AGENDA

REGULAR MEETING OF THE BIRMINGHAM MULTI-MODAL TRANSPORTATION

BOARD THURSDAY DECEMBER 1ST, 2022

SUBJECT: 34350 Woodward & 909-911 Haynes Street - Fred Lavery Porsche – Community Impact Study & Preliminary Site Plan Review

Woodward/Elm (C2)

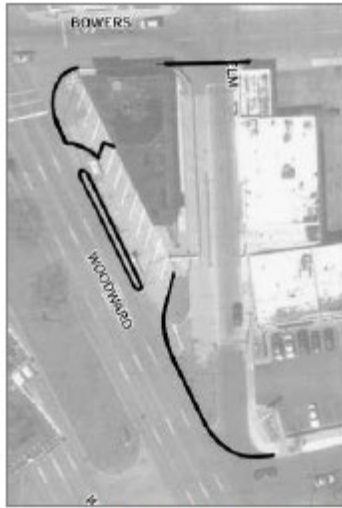
Option B, named 'C2' in The Plan, proposes that this portion of Elm south of Bowers could be converted to southbound traffic only with the former northbound lanes converted to angled street parking.

Woodward/Elm (C1)

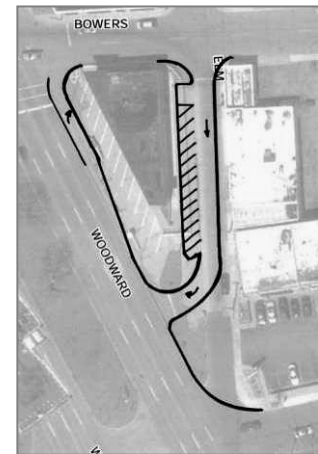
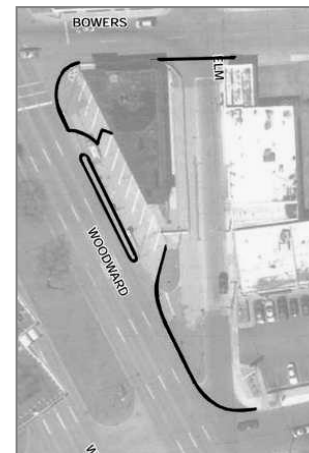
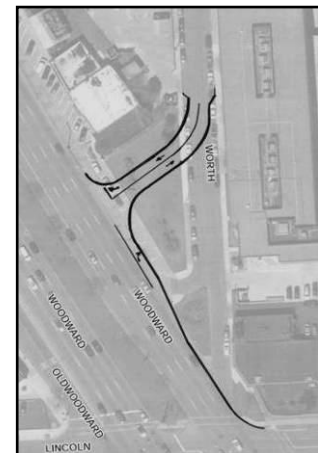
Option A, referred to as 'CI' in The Plan, proposes that the intersection of Elm at Woodward should be reconfigured to require traffic entering the District at Elm to make a right turning movement rather than merely veering right. The Plan states that "this would slow traffic and improve safety for pedestrians and motorists."

The MMTB should review and discuss these options and provide a recommendation for the design for Fred Lavery to incorporate for Final Site Plan and Special Land Use Permit application review.

Move to recommend to the Planning Board that the applicant incorporate option _____ into their Final Site Plan and SLUP application.

1 SITE AND LANDSCAPE PLAN
A/LA 100.1
SCALE 1/8" = 1'-0"

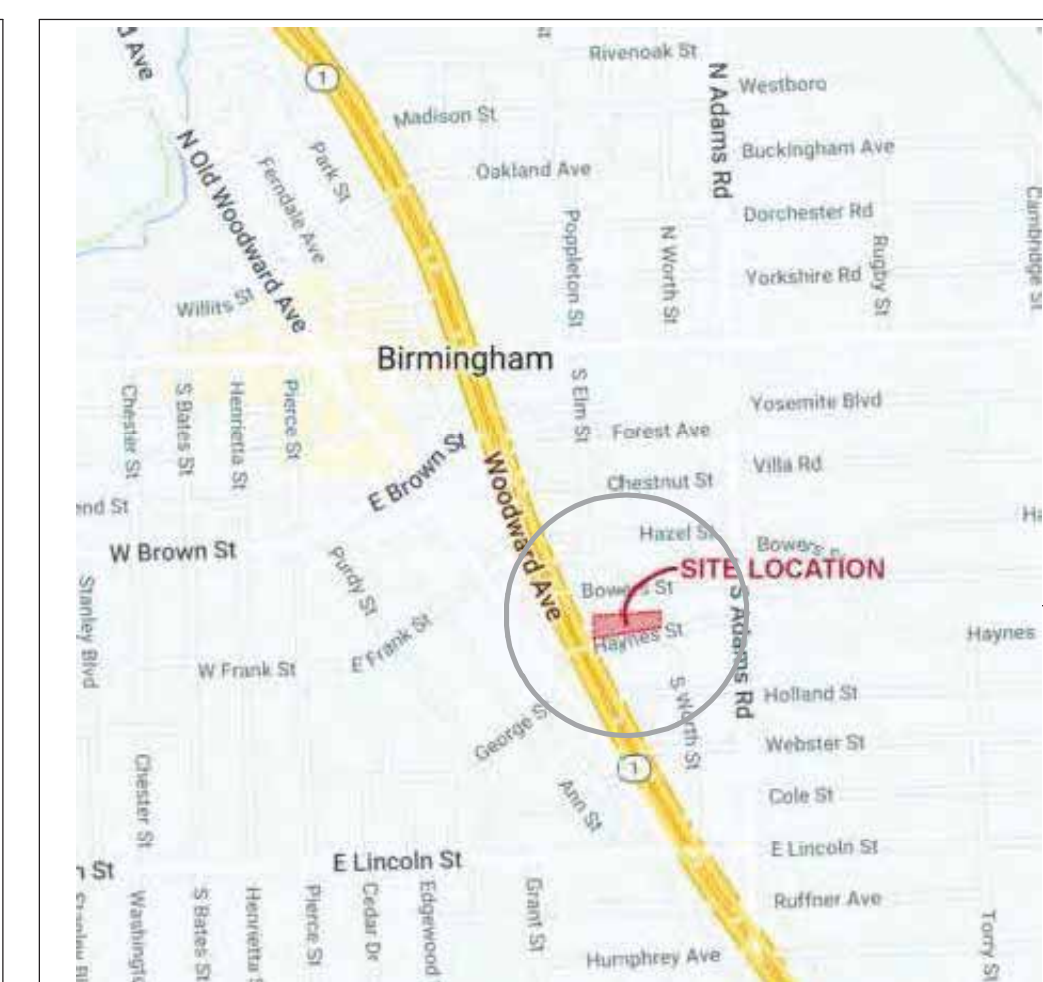
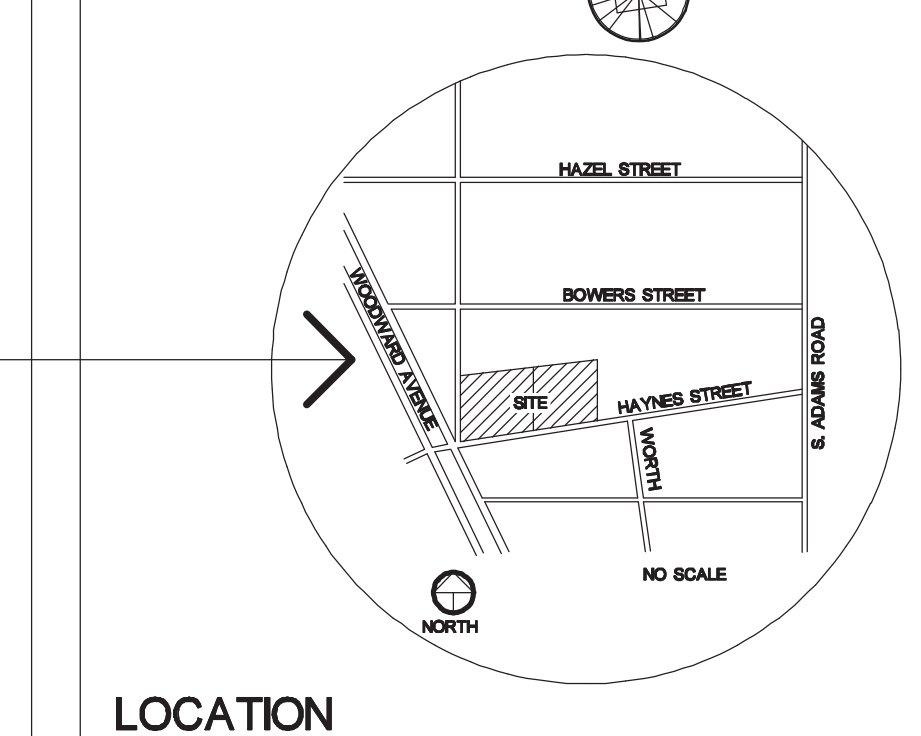
Streetscape Elements – The applicant has provided a number of street trees, street lights, and streetscape furnishings. In terms of street trees, Article 4, Section 4.20 (G) requires at least 1 street tree for each 40 linear feet of frontage along a street. The site plan indicates a total of 11 street trees which satisfies the ordinance

In regards to streetscape furnishings, the applicant has proposed 3 benches, 3 trash receptacles, and 5 bike racks along Haynes Street. All benches, bike racks, and trash receptacles are expected to meet the streetscape standards of the Triangle District. **The Planning Division recommends additional benches at the showroom entrance.**

Section 3, Article 3.12(B) requires sidewalks in the Triangle Overlay District to be a minimum of 12 feet wide. Prior decisions by the Planning Board with 750 Forest incorporated the "furnishing zone" in the required 12 foot sidewalk. The sidewalk surrounding the building appears to be between 10-12 feet along Haynes and Elm Street. **The applicant must adjust the site plan to provide 12 feet of sidewalk space surrounding the entire property or obtain a variance from the Board of Zoning Appeals.**

It is of note that the Engineering Department has commented that the applicant will be required to move the utility pole on Elm Street. Issues with streetscape elements and pedestrian sighting from the proposed driveway could also arise. **The Planning Board may wish to discuss the placement of streetscape elements on the northwest corner of the property.**

FIGURE 1: INTERSECTION SIGHT DISTANCE

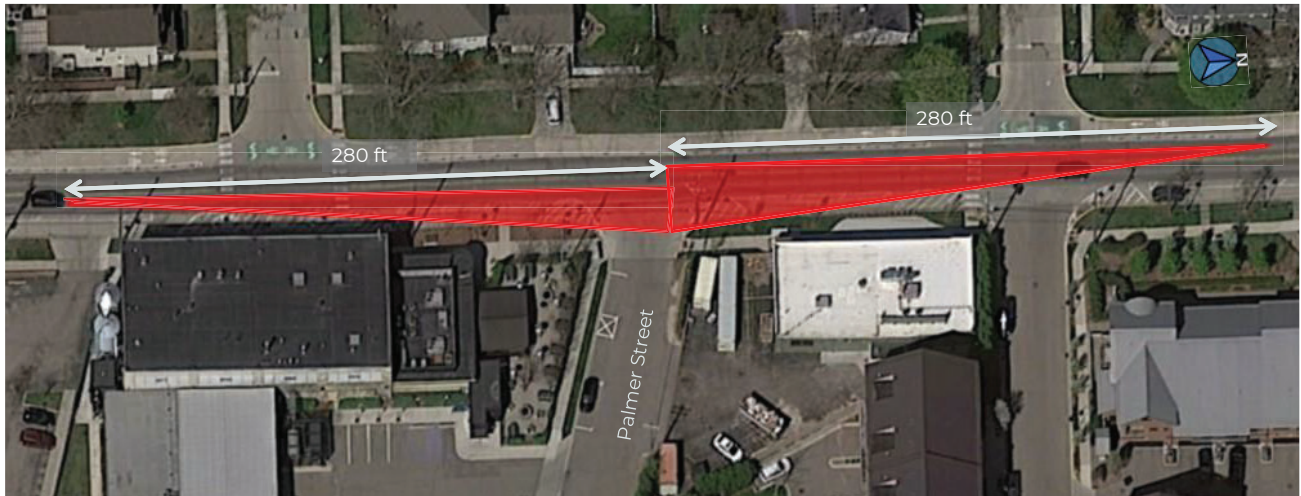
The intersection sight distance evaluation is shown on Figure 1, there is not adequate sight distance due to the on-street parking. Based upon this review, all of the on-street parking would need to be eliminated to meet the sight distance recommendation. However, in urban areas this is not practical. Therefore, the MMUTCD provides guidelines for on-street parking from an intersection. The minimum requirement is 15ft and 37ft is provided, as shown in **Figure 2**.

- Based upon this review, the existing design meets the MMUTCD criteria for intersections with on-street parking. The crash data shows that only one (1) crash at this intersection has occurred since the existing bump-outs were added in 2019. Therefore, there is not a crash pattern at this intersection with the existing configuration.
- S. Eton is scheduled to be reconstructed in FY 2023 and the future designs will be developed to consider on-street parking, intersection alignment and other design considerations.
- Existing vegetation in the vicinity of the existing should be cleared to insure adequate sight distance.
